# **BriSCA F2 Technical Bulletin**

## **2016 Rule Changes, Clarifications & Reminders**

### **2<sup>nd</sup> January 2016**

### **Version 2.1**

## 203.2.4 - Chassis/Bumper Centrelines

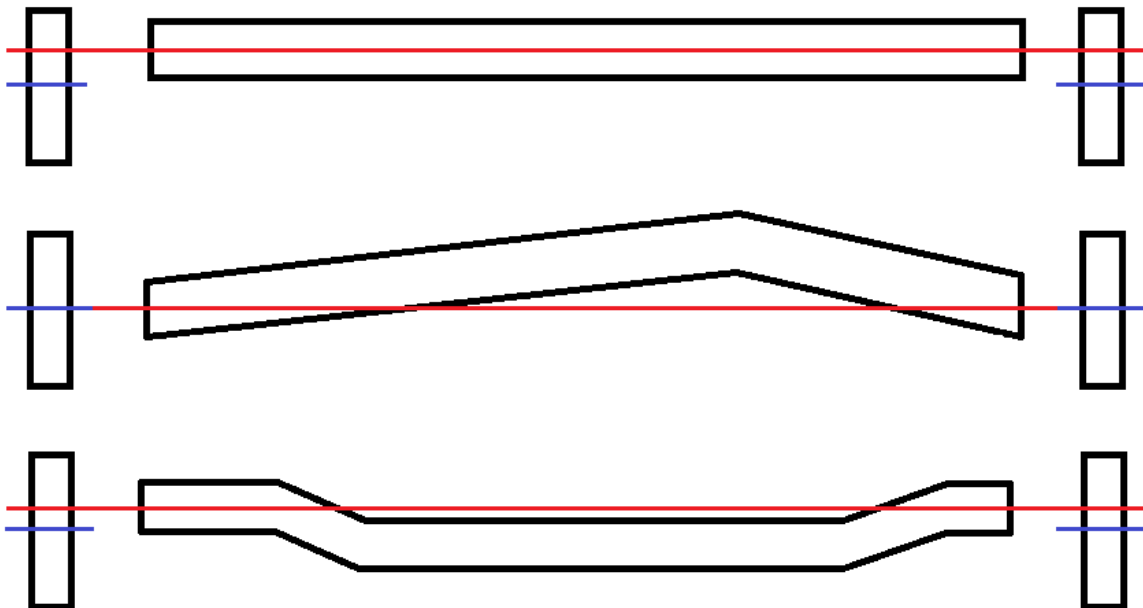
The wording of the rule is currently unclear, and depending on interpretation could be seen to unintentionally outlaw the old HCD Dozer type chassis, and other non-flat chassis designs where constructors have sought to use raised, lowered or angled main-rails.

- The diagrams below illustrate some examples of what is intended by this rule. The horizontal red lines through the vertical centre of the two ends of the main chassis rail (where the bumpers or their bracing attach) pass through or above the vertical centre of the bumper blades (denoted by the blue lines). (It is the blue lines that are then measured for their distance to the ground for ride height as specified in rule 204.8.)
- The three illustrations below would all be legal to the intention of the rule, and therefore the wording of the rule to be published in the rulebook will be changed for clarity but NOT for meaning or its intention.
- At the present time there are no **known** cars that do not meet this specification, but questions of clarity have been asked during the 2015 season.

## 203.4.2 - Roof Plate

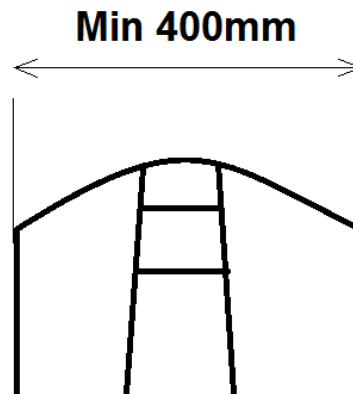
- “203.4.2 - The roof plate **MUST** measure at least a **MINIMUM** of 560mm in length across its entire width, and at least a **MINIMUM** of 400mm in width along the mandated **MINIMUM** 560mm length. These dimensions include the diameter of the roll-cage tube to which the plate is welded, and will therefore be measured from two verticals butting against the outside of the roll-cage tube.”

- The measurement between the two verticals is taken in the horizontal plane parallel to the ground, and therefore is the straight distance between the two verticals and not simply the dimensions of the physical roof plate whether it be curved or not.

### **214 - Front Beam Axles**

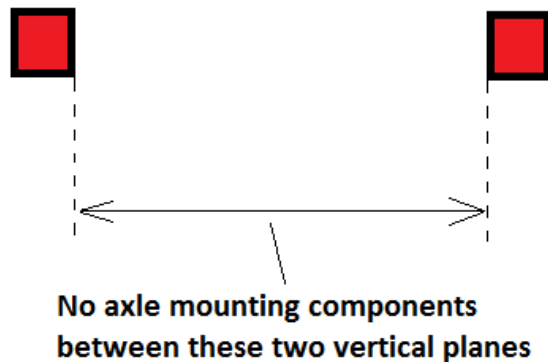
- In an effort to prevent the formula form heading in an undesirable direction in the future, it is proposed that the wording of 214.1.1 will be changed with effect from **1-Jan-2017** to state, *"It is permitted to use either a solid **1-piece** beam-axle, or an independent **wishbone** design for the front axle/suspension"*.

The alteration of camber angles continues to be permitted. In order to ensure that current permitted designs are not unintentionally outlawed by any additional new rule wording, research will be carried out during 2016 to ensure that any new rule(s) take account of currently acceptable designs/practices.

## **204 - Bumpers**

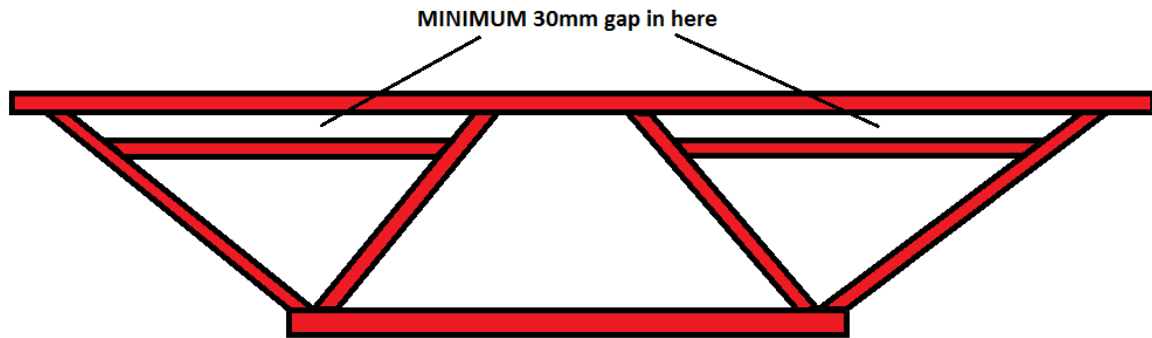
- From 2016 onwards the welding of additional transverse material, e.g. SHS or RHS, to the inner side of bumper faces (for strengthening or any other purpose) will NOT be permitted (effective 01-Jan-2016).
- From 2016 onwards double thickness bumpers with additional lengths of box section welded in parallel to the inner face of the bumper will NOT be permitted (effective 01-Jan-2016).
- The use of small sections of steel plate, welded to the inner side of the bumper face, on to which diagonal bracing is welded WILL still be permitted.

- A MINIMUM gap of 30mm is required between the bumper face and any additional transverse bracing.

- The use of small sections of plate, welded to the **FRONT** face of the bumper blade, to effect repair, or provide strengthening for bends, **is permitted**, subject to the following:

- The **MAXIMUM** plate size permitted is 100mm x 100mm.
  - The **MAXIMUM** plate thickness permitted is 5mm.
  - It is **NOT** permitted to double-stack, overlap, or join plates together.

- When added to the existing bumper blade, the total overall thickness must **NOT** exceed the permitted 30mm (2015 rule 204.4).
- The use of small sections of plate, welded on the **REAR** face of the bumper blade, in to which the diagonal bracing is run, or used to provide strengthening/support for diagonal bracing, **IS** permitted, subject to the following:

- The **MAXIMUM** plate size permitted is 100mm x 100mm.
  - The **MAXIMUM** plate thickness permitted is 5mm.
  - It is **NOT** permitted to double-stack, overlap, or join plates together.

- Plates may only be used where a brace runs in to the bumper blade.
  - Such plates are **NOT** included in the total overall thickness measurement for the current rule 204.4 (maximum 30mm).
